AW-95-908

November 30, 1995

SUBJECT: WESTINGHOUSE RESPONSES TO NRC REQUESTS FOR ADDITIONAL
INFORMATION ON THE AP600

Figure 440.492-42 NOTRUMP - Upper Plenum Void Fraction for Test SB14

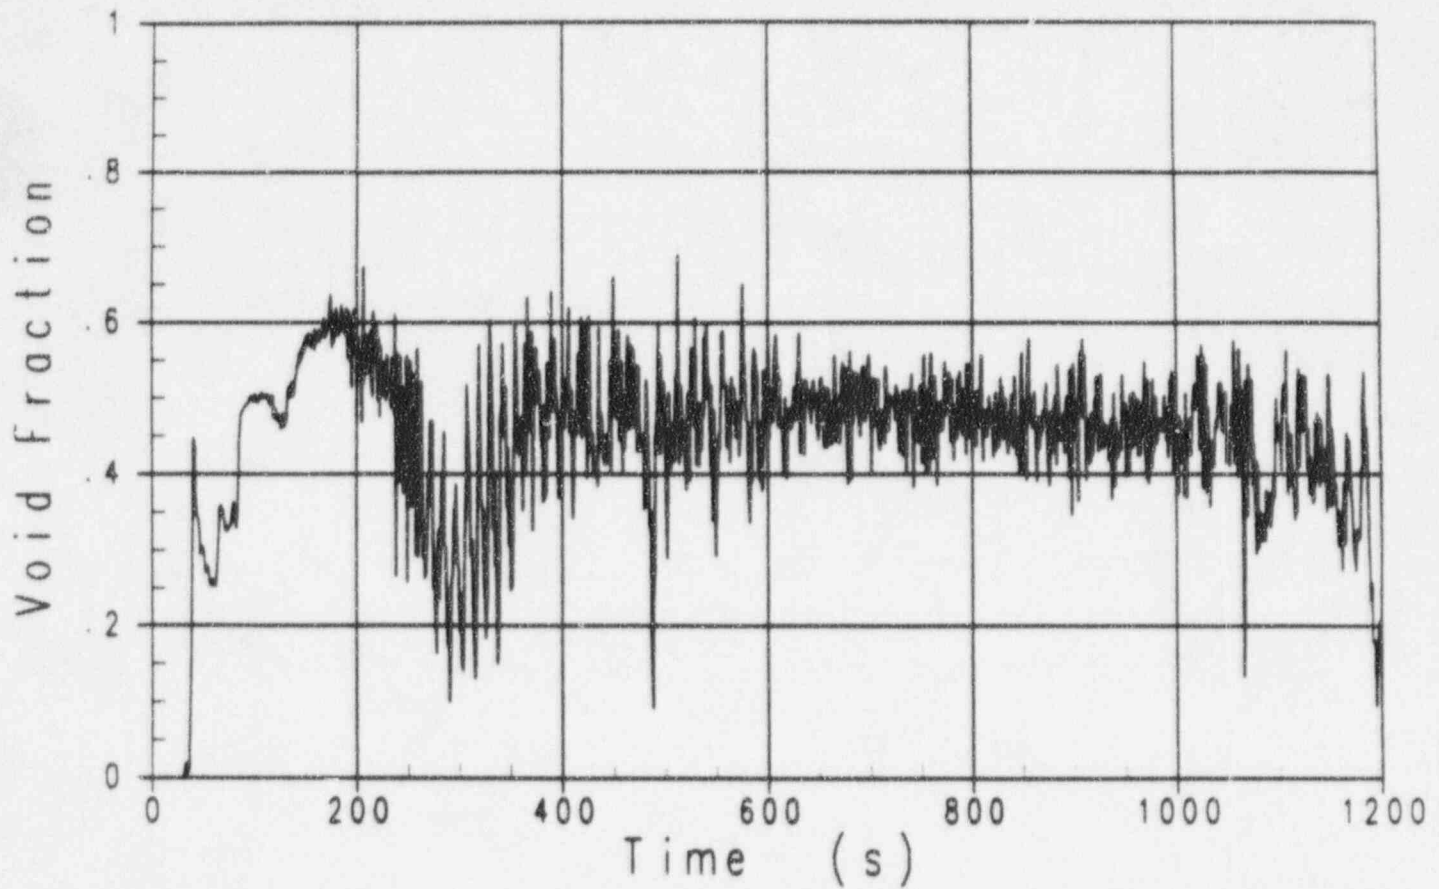
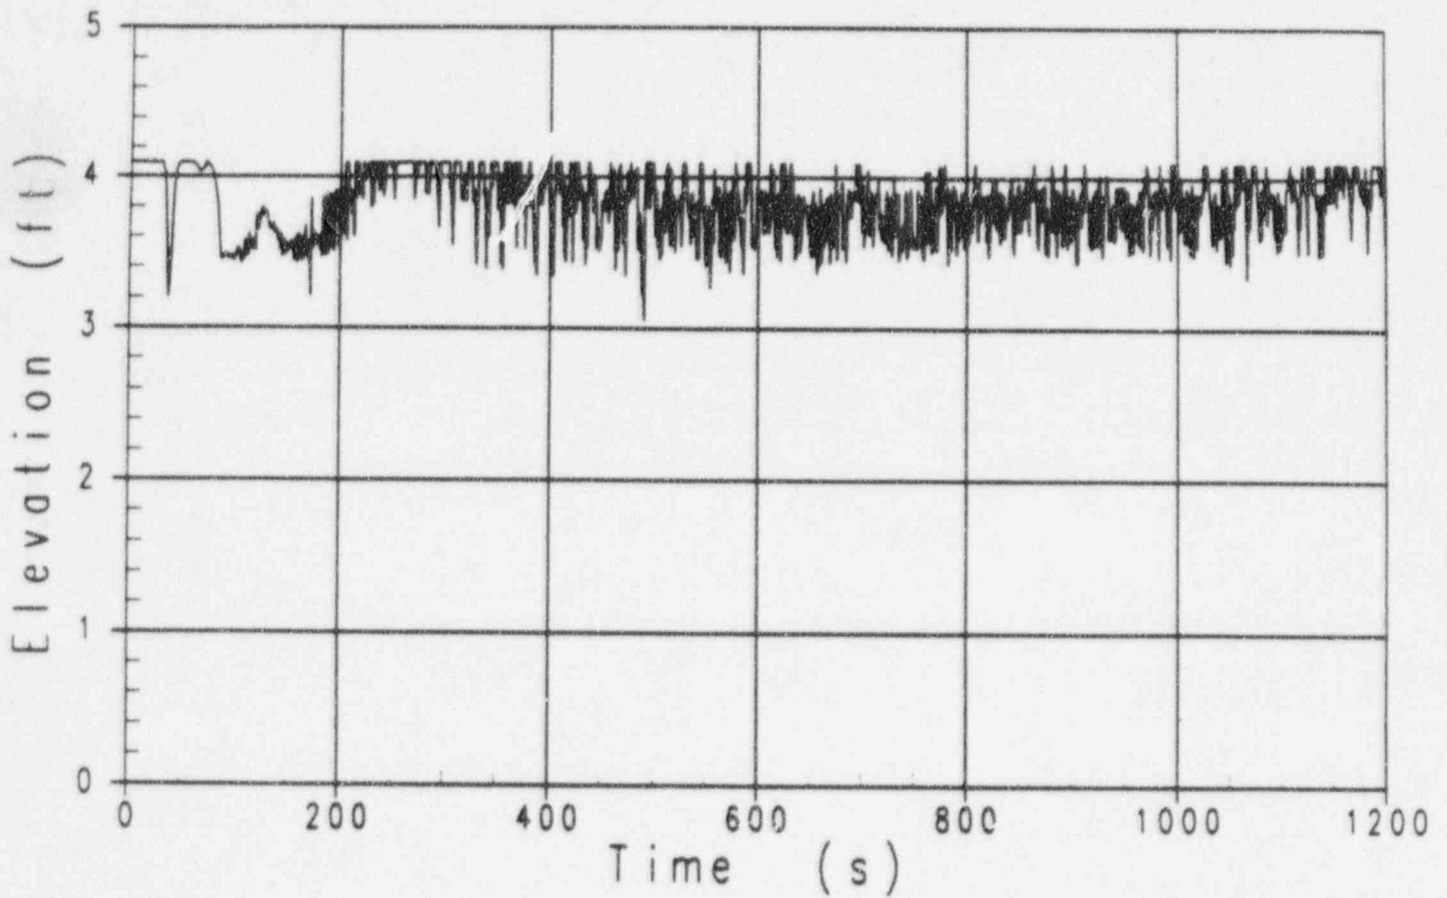
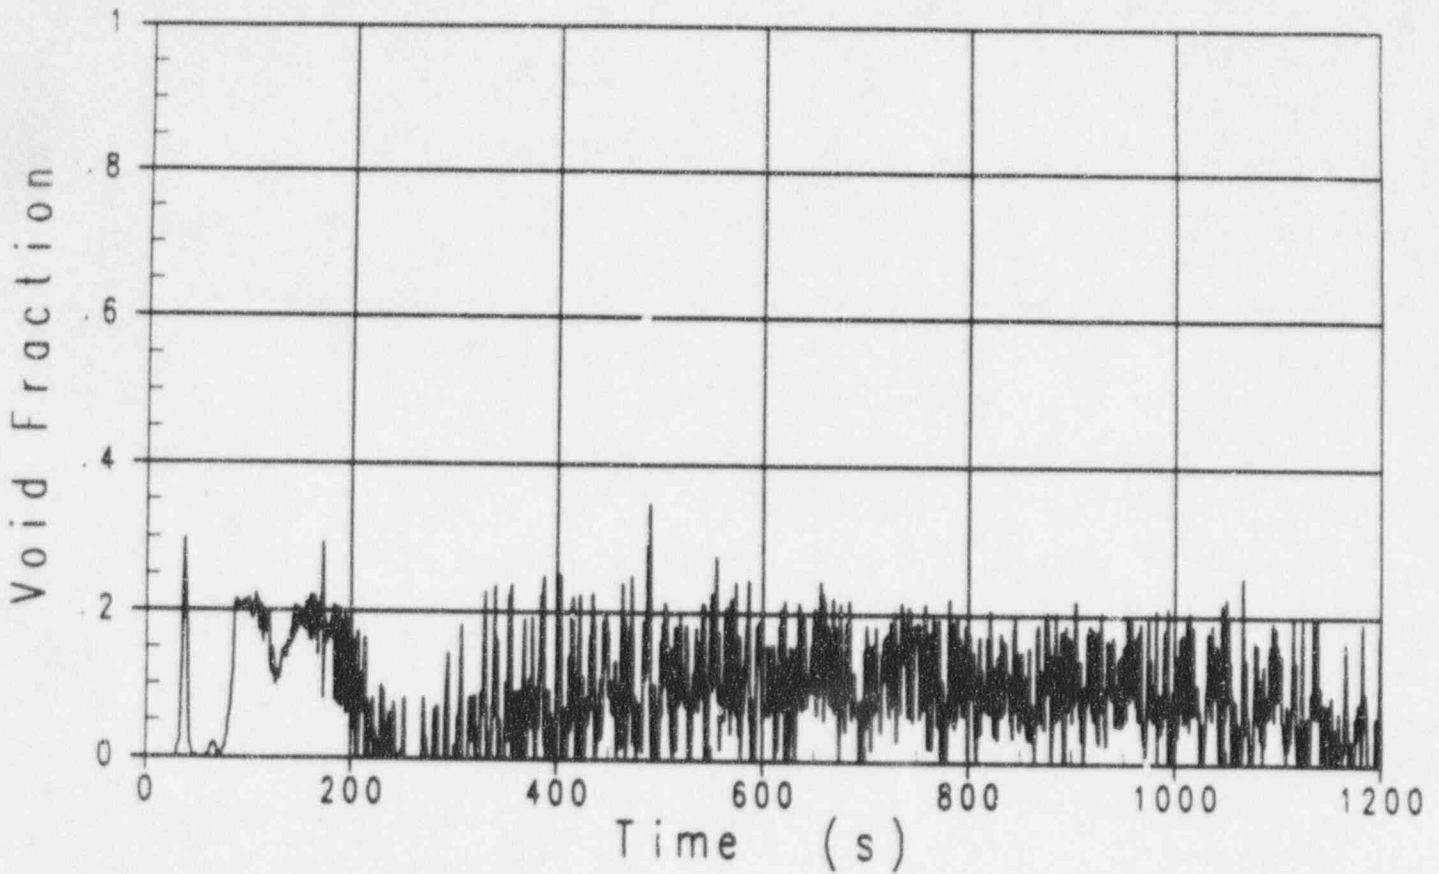
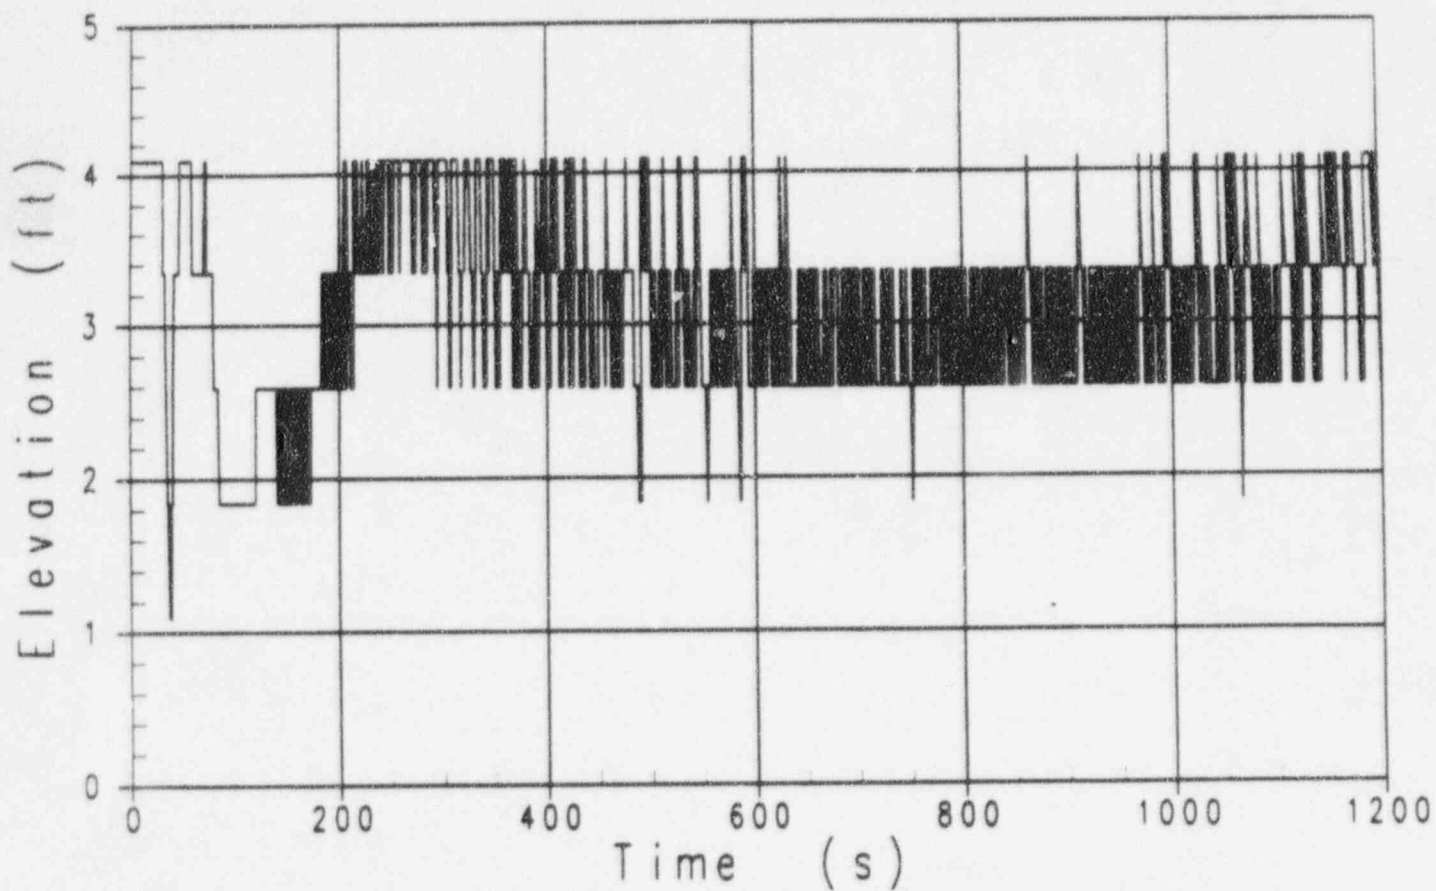
Please provide the core inlet and bypass mass flow rate predictions for the blind two inch cold leg balance line break of Section 5.2. Also, provide the liquid level plots for the upper plenum and core region and the void distribution in the core region.

The requested NOTRUMP core inlet and core bypass mass flow rate predictions for this test are provided in the response to RAI 440.491.
